**DEPARTMENT OF TRANSPORTATION
STATE OF GEORGIA**

SUBJECT APPROVED REVISED PROJECT CONCEPT REPORT

REVISED PROJECT CONCEPT REPORT

Project: NH-IM-95-1(120) PI 511110, McIntosh County - widening and reconstruction.
NH-IM-95-1(150) PI 511112, McIntosh County - bridge widening and replacement.
NH-IM-95-1(136) PI 511115, McIntosh County - Phase 2

SKETCH MAP OF SR251 INTERCHANGE

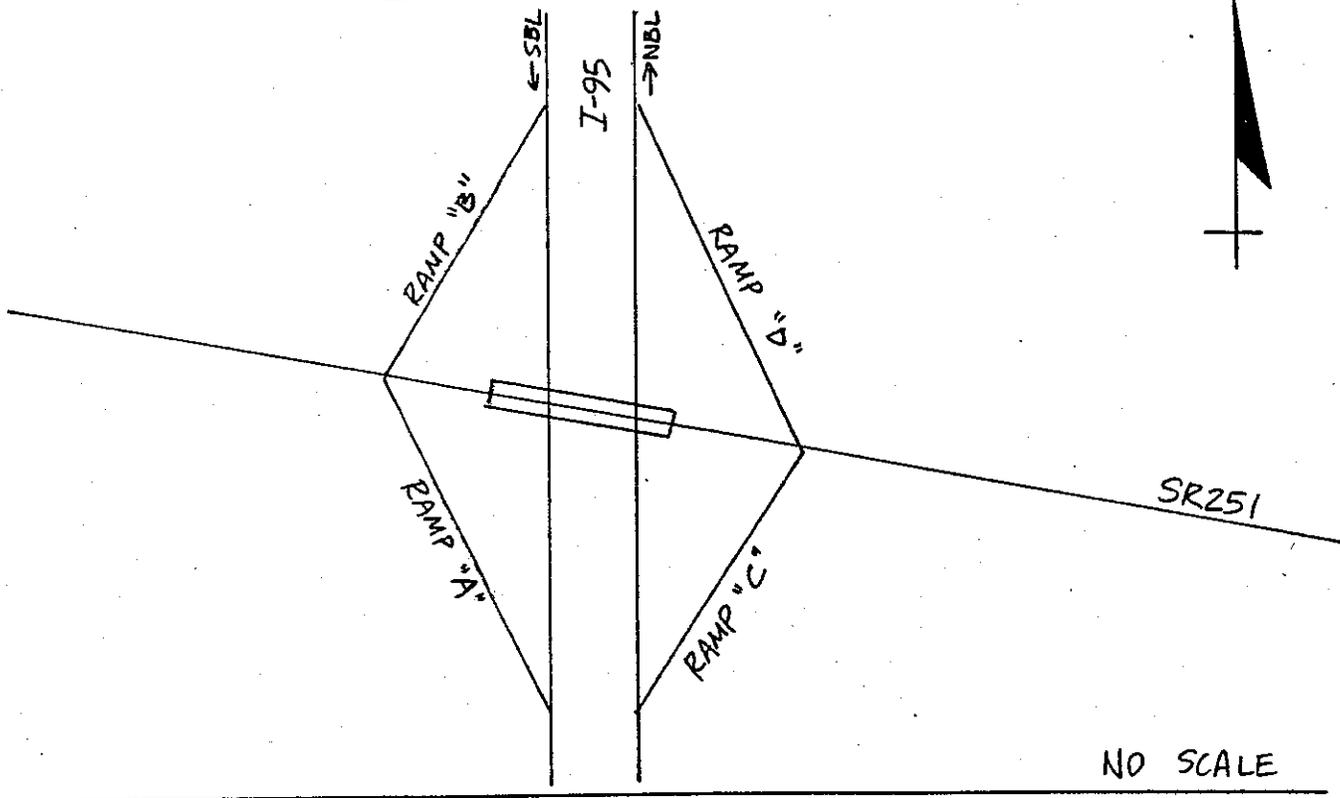
Interchange modifications are proposed for SR251. Due to a 3.66m (12 foot) lateral clearance from the edge of the existing I-95 lanes to the face of the bridge columns, it will be necessary to replace the SR251 overpass. The new SR251 bridge will be constructed parallel to the existing overpass and approximately 19.8m (65 feet) to the south. This will result in rebuilding about 823m (2700 feet) of SR251 and adjusting each of the ramp intersections. This work should require only minor right of way or easements and will be stage constructed under traffic. In addition, a right turn decel will be added to Ramp "C" to increase the operating capacity of this unsignaled intersection with SR251. See also the sketch map on page 4.

Proposed features to be revised: Remove the bridge jacking of the SR 251 Bridge over I-95 from Project NH-IM-95-1(120) and retain the current bridge as is. Update the cost estimates of NH-IM-95-1(120) and NH-IM-95-1(136).

Describe the revised feature(s) to be approved: The revised concept report dated October 15, 2002 added the required jacking of the existing bridge carrying SR 251 over I-95 in lieu of its replacement which was in the original approved concept report for NH-IM-95-1(120) dated September 7, 1994. The revised concept report (dated 10/15/2002) indicated that the replacement of the SR251/I-95 overpass bridge would occur under project STP 2387(4) PI 542070. The concept report for STP-2387 (4), which represents the widening of SR 251, was approved on July 13, 2004. With the bridge, ramps and approaches for the I-95/SR 251 interchange being shown as an exception in project STP 2387(4), the report indicated that the interchange would be reconstructed under NH-IM-95-1(120) as a part of the I-95 widening project. Subsequently, in 2005, the Department programmed project CSNHS-0007-00(421) which represents the complete reconstruction of the I-95/ SR 251 Interchange including the ramps, the bridge over I-95 and the bridge approaches on SR 251. This project will be developed as a project that can be constructed concurrently with or in advance of the SR 251 widening project. The purpose of this revised concept report is to revise project NH-IM-95-1(120) to remove any reference to bridge jacking or interchange reconstruction and update the cost estimates for projects NH-IM-95-1(120) and NH-IM-95-1(136) Therefore, Project NH-IM-95-1(120) will only represent the widening of I-95 to six lanes. Please note that a **Design Exception** was approved on May 12, 2005 for substandard shoulder width on I-95 under the existing SR 251 bridge for Project NH-IM-

95-1(120) allowing the existing bridge to be retained in its current state for the Phase I widening of I-95. This substandard shoulder width will be eliminated with a new bridge under project CSNHS-0007-00(421) which is currently programmed for FY 2009.

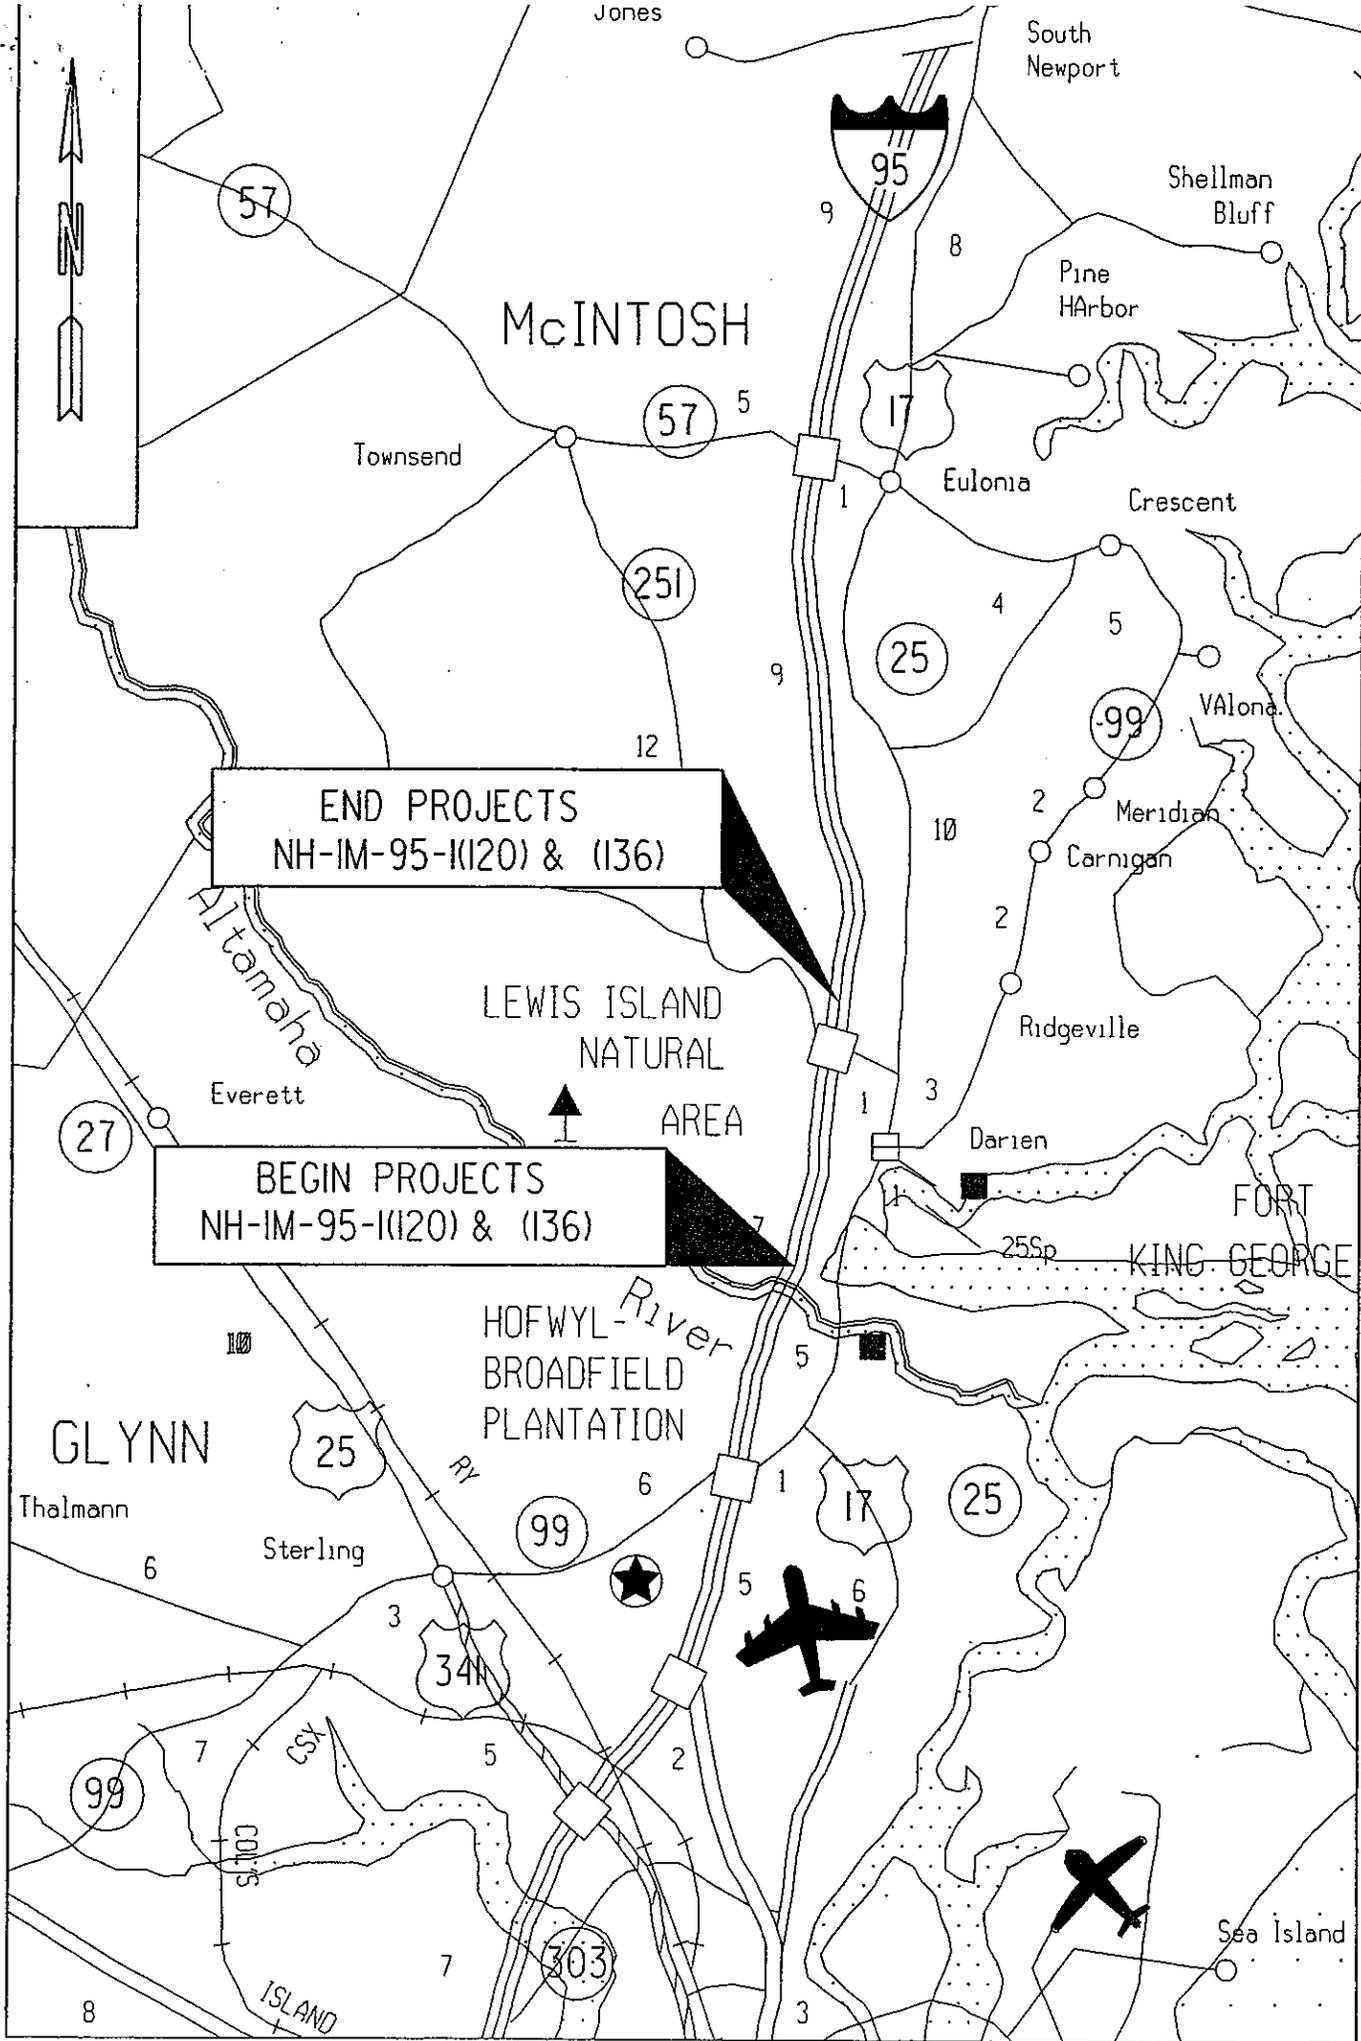
Proposed features to be revised: The project beginning terminus will be shortened to match the project ending termini for Project NH-IM-95-1(117) (see attached location sketch). Also, the SR251 Overpass Bridge will not be replaced but instead will be jacked.

Describe the revised feature(s) to be approved: This concept is being revised to relocate the beginning project terminus. The new beginning terminus will be located just north of the Altamaha River Bridge at the Glynn/McIntosh County line. The new beginning terminus is being revised to match the project ending terminus for NH-IM-95-1(117). The approved concept report shows the SR251 Overpass Bridge as being replaced in Phase I of this project. The concept is being revised to jack the bridge to accommodate the asphaltic overlay constructed on I-95. This bridge will be replaced under Project STP-2387(4) McIntosh which is scheduled to be let in 2007.
